SUBJECT: DELIVERY HOLD - Safety Recall 12S36
Certain 2011-2012 Model Year Transit Connect Vehicles
Wiper Arm Replacement

CERTAIN 2011-2012 MODEL YEAR TRANSIT CONNECT VEHICLES — WIPER ARM REPLACEMENT

FIGURE 1

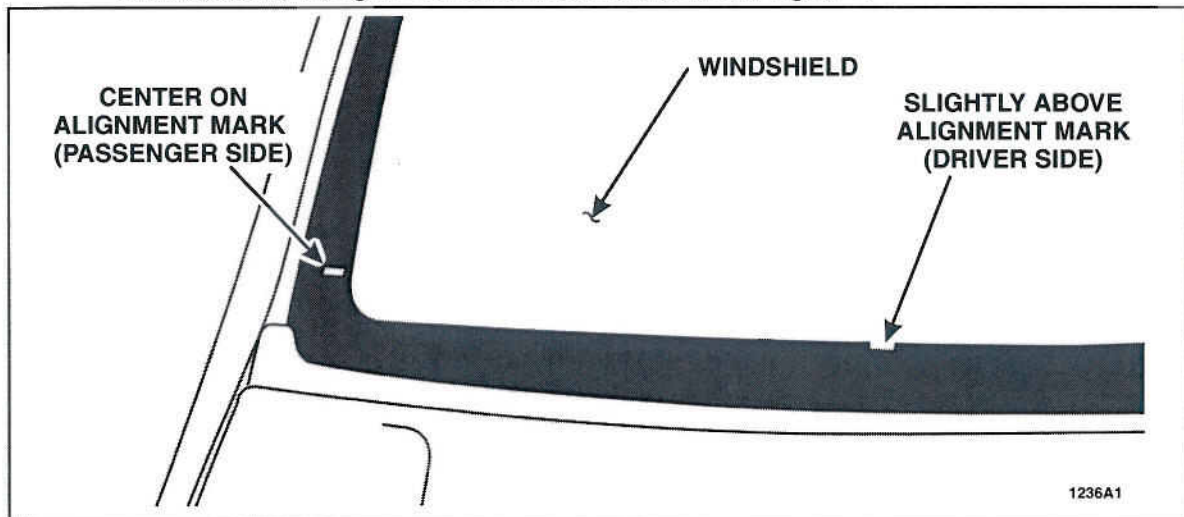
- Install *new* wiper blades onto the *new* RH and LH wiper arms.
- Verify that the RH windshield wiper blade position is centered within the clear portion of the passenger side alignment mark. See Figure 1.
- Verify that the LH windshield wiper blade position is slightly above the driver side alignment mark located to the right of center on the windshield. See Figure 1.
